Community and Stakeholder Engagement Report

Improving connectivity from Curl Curl to Freshwater (Stage 2 of 2)

Consultation period: 17 November to 15 December 2021

Figure 5:
Configuration proposed for Option 1A, adjusted to meet TNSW's recommended lane widths
(Source: Northern Beaches Council)

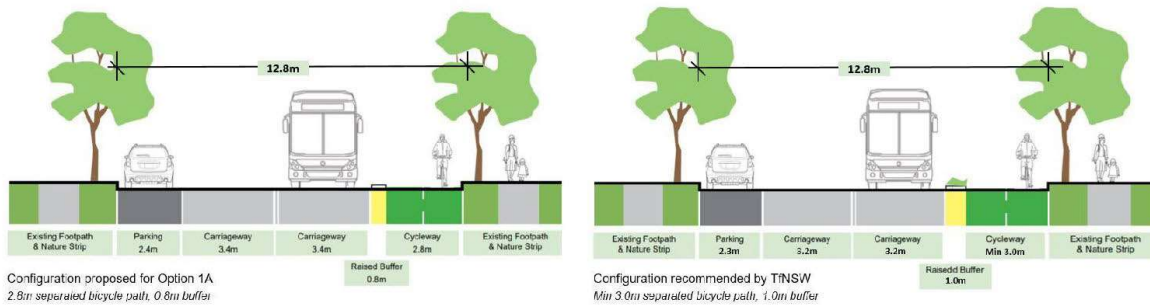
- **Option 1B could be considered for some sections, but with a 2.4m wide bicycle path.**

Figure 7: Configuration proposed for Option 1B, adjusted to meet TfNSW's recommended lane widths (Source: Northern Beaches Council)

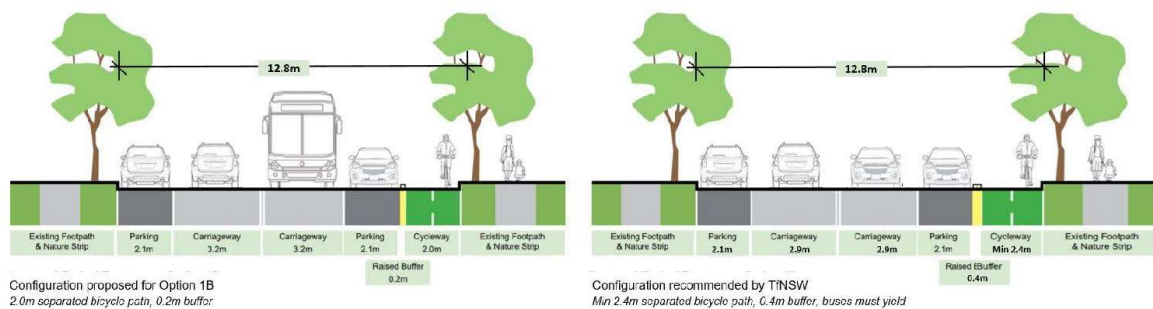
Where buses do not pass regularly, it may be possible to retain parking on both sides of the road and create an adequate bicycle path by narrowing the vehicle and parking lanes. The Cycleway Design Toolbox suggests the configuration shown in Figure 6 to achieve an acceptable 2.4m bicycle path with a 40cm buffer. Figure 7 demonstrates how Option 1B could be adjusted to create the recommended layout.

For the section of the Freshwater to Curl Curl route south of Wyndora Avenue, this treatment is worth exploring. Buses do not use the southern stretch of Oliver Street and the on-street parking is particularly valuable close to the shopping village, the weekend markets, the community centre and St John's Primary School.

There may be short sections of the corridor further north where a bus could be expected to yield to an oncoming traffic. A stretch of the Option 1B layout, with lanes adjusted to create the 2.4m wide bicycle path, could be introduced.

Proposed Typical Treatment - Option 1A
Two-way Separated Cycleway (2.8m wide)
Parking removed from eastern side of street

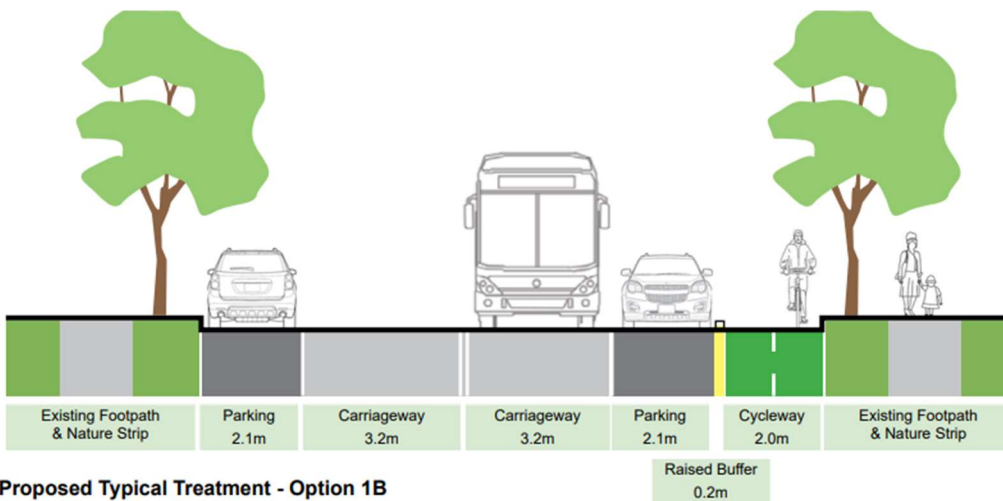
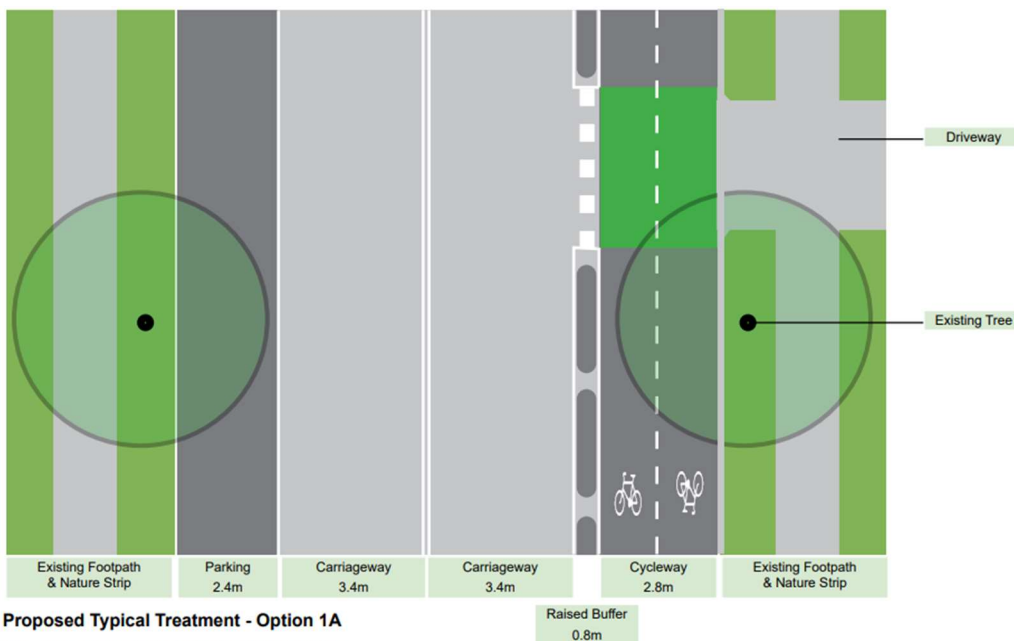
With BOTH option 1A and 1B the cycle lane width does not allow for a 2 cyclists in each direction in PEAK use days.

OPTION 1 C

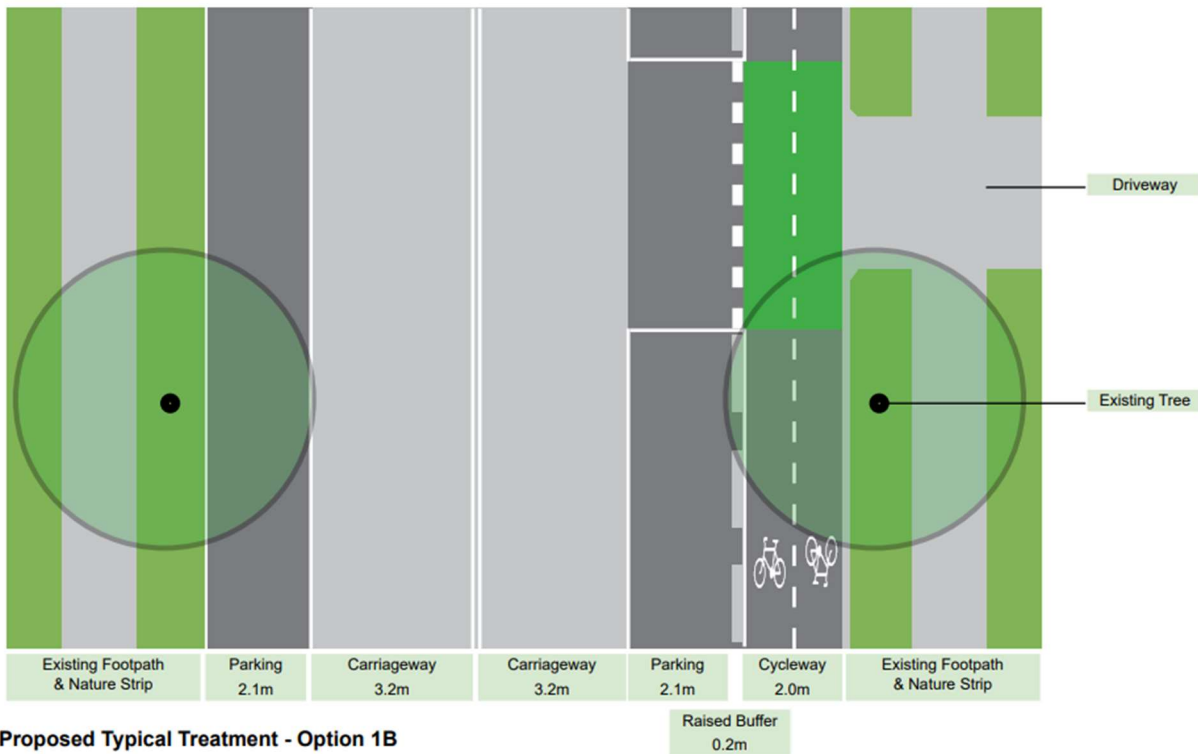
So an OPTION that provides a wider Cycleway perhaps by removing the EXISTING TREE and Widening the Cycleway (using part of the Nature Strip ?) and FIXING the kerb (as has been done in City of Sydney in George Street for widening the walking space adjacent to the Light Rail Route).

This preserves the 2-way CAR LANE LAYOUT.(but losing a row of Street Trees which can be re-planted on the other side of Street or perhaps within the NATURE STRIP if width allows ?).
